Access Compliance Report

Public Rights-of-Way

(Curb Ramps)

Intersection ID: 20587	Main Street: COLONY_RD	Cross Street: FAIRVIEW_RD	Location: SE
ADA ID: F2CBC199A59A	Ramp Type: Perp	Initial Pass/Fail: Fail	Overall Compliance: No
Severity Score: 12.5			
Codes/Mitigation Info/Possible Solution		Field Measurements/Component Compliance

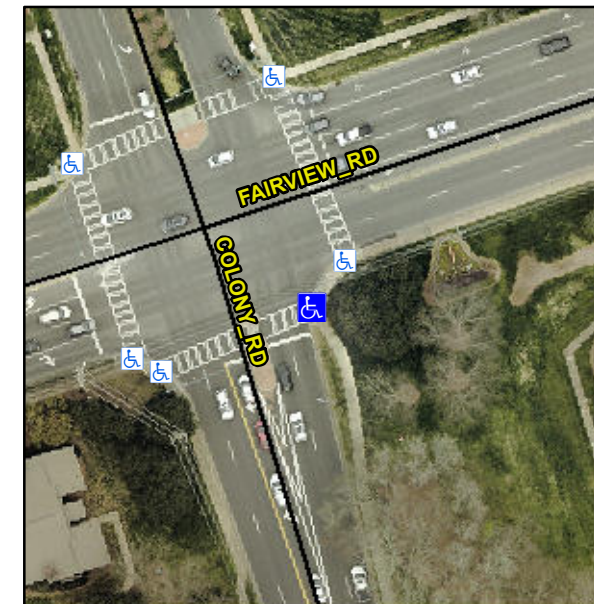
R304.5.3

Compliance	Description	Data	Compliance	Description	Data
N/A	Ramp Length (in)	73.0	Yes	Ramp Slope (%)	6.2
Yes	Ramp Width (in)	48.0	No	Ramp XSlope (%)	5.9
N/A	Flare Type LT	N/A	N/A	Flare Type RT	N/A
N/A	Flare Slope LT (%)	N/A	N/A	Flare Slope RT (%)	N/A
N/A	Flare Traversable LT?	N/A	N/A	Flare Traversable RT?	N/A
N/A	Landing Length (in)	N/A	N/A	DWS Provided?	N/A
N/A	Landing Width (in)	N/A	N/A	DWS Contrast?	N/A
N/A	Landing Slope (%)	N/A	N/A	DWS Length (in)	N/A
N/A	Landing X Slope (%)	N/A	N/A	DWS Full Width?	N/A
N/A	Landing Curb? (Y/N)	N/A	N/A	DWS Offset (in)	N/A
N/A	Shared Landing?	N/A			
N/A	Gutter Ponding?	N/A	N/A	Gutter Slope (%)	N/A
N/A	Gutter Lip Ht (in)	N/A	N/A	Gutter X Slope (%)	N/A
N/A	Painted X Walk1?	Yes	N/A	Painted X Walk2?	N/A
	X Walk 1 Direction	To SW		X Walk 2 Direction	N/A
N/A	X Walk 1 Width (in)	105.0	N/A	X Walk 2 Width (in)	N/A
	X Walk 1 Slope (%)	1.9		X Walk 2 Slope (%)	N/A
	X Walk 1 X Slope (%)	2.8		X Walk 2 X Slope (%)	N/A

Remove & Replace Entire Ramp.
